**S-TYPE**

S303-S145

SERVICE**TECHNICAL BULLETIN**

Coolant Level Sensor Contamination –
Disable Sensor –
Service Action S145

ILLUSTRATION 1

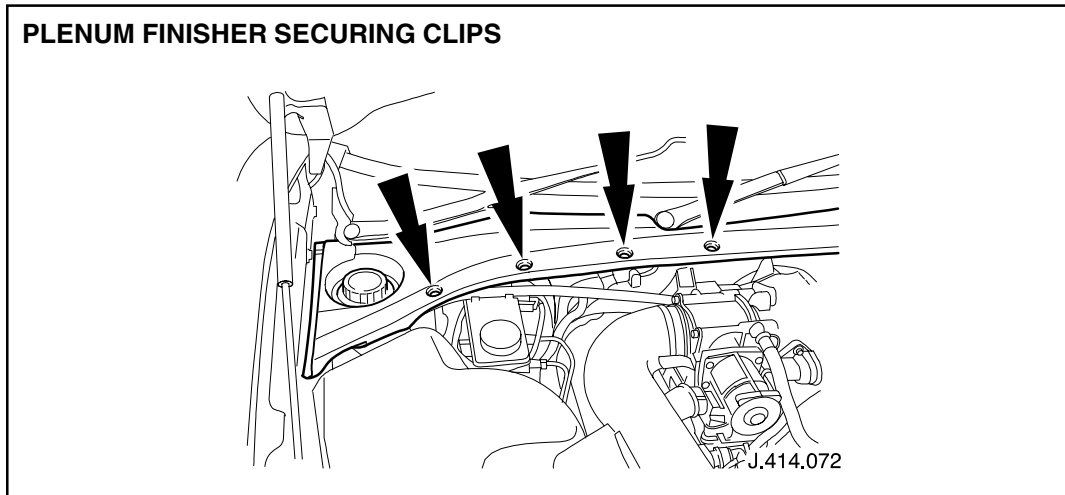
4. Open hood and place protection covers over fenders.
5. Remove plastic securing clips from driver's side of plenum finisher (Illustration 1).

ILLUSTRATION 2

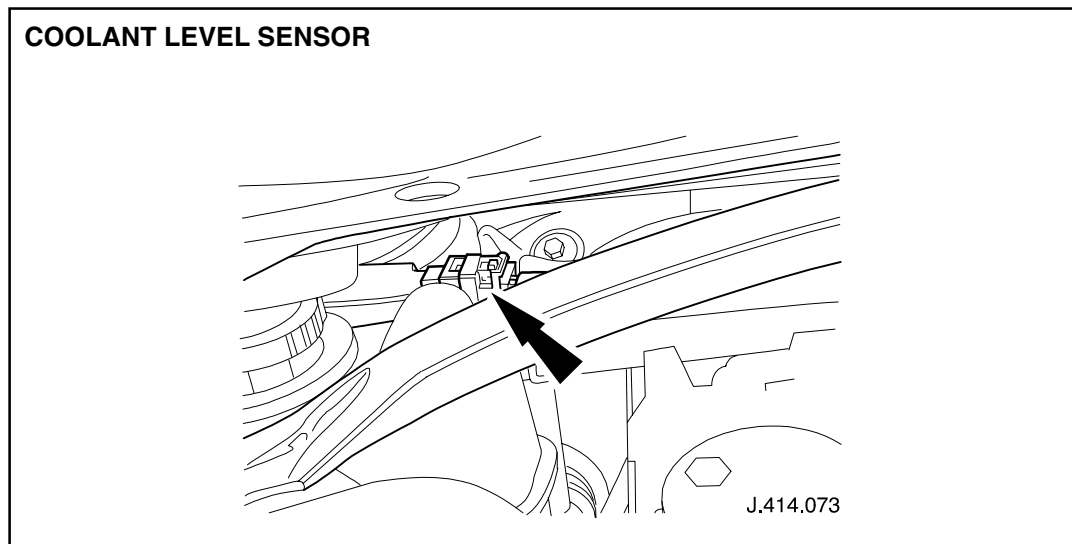
6. Reposition front edge of driver's side of plenum finisher upwards as required and disconnect coolant low-level sensor connector (Illustration 2).

ILLUSTRATION 3

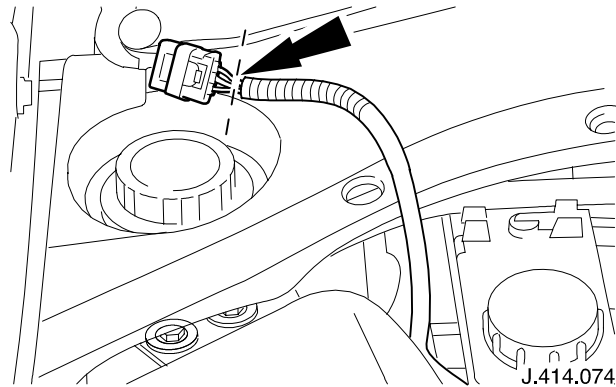
CUT CABLE CLOSE TO CONNECTOR

7. Reposition sensor connector plug lead for access and cut sensor cable as close to connector as possible and discard connector (Illustration 3).
8. Release plenum finisher.
9. Reposition sensor cable forward from plenum area into engine bay.

ILLUSTRATION 4

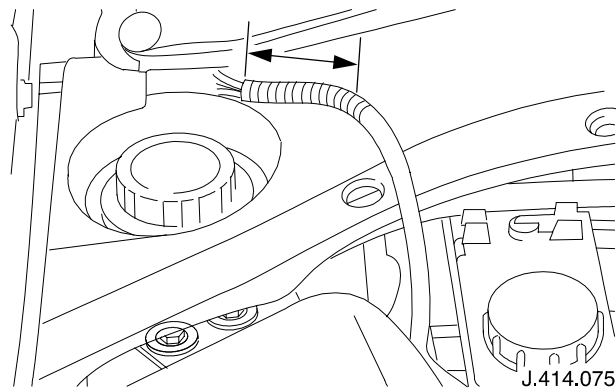
STRIP BACK CABLE WRAPPING

10. Strip back sensor cable tape wrapping and convoluted tubing to approximately 60 mm back from end of cable (Illustration 4).
11. Fit heat shrink tube (418-104) from harness repair kit halfway onto end of each cut wire.
12. Using a suitable hot air gun, shrink tubing onto each wire.
13. Using a suitable tool, squeeze to seal each end of heat shrink tubing before sealant sets.
